# UNITED STATES PATENT AND TRADEMARK OFFICE

10/590,044

<b>Office Action Summary</b>	<b>Application No.</b> 10/590,044	<b>Applicant(s)</b> KUENZI ET AL.	
	<b>Examiner</b> Larry E. Waggle, Jr	<b>Art Unit</b> 3775

## **DETAILED ACTION**

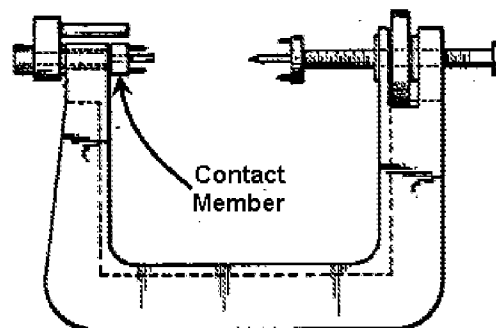
**Claims 1-2 and 8-9** are rejected under 35 U.S.C. 102(b) as being anticipated by Saunders et al. (EP 132284 A1).

Saunders et al. disclose an aiming device comprising a U-shaped bow (1) having at least one contact element (i.e. member including 7; see annotated Figure below) at a first end of the bow and, at a second end of the bow a screw spindle (5) movable towards and away from the contact element and having a rotary grip (4; i.e. nut) mounted in a recess of the bow and pin (3); and a drill bushing (12), wherein the drill bushing is removably inserted (via 13) through the contact element and a bone compression produced by the bow persisting after removal of the drill bushing (Figures 1-2 and page 4, lines 1 – page 5, line 10).
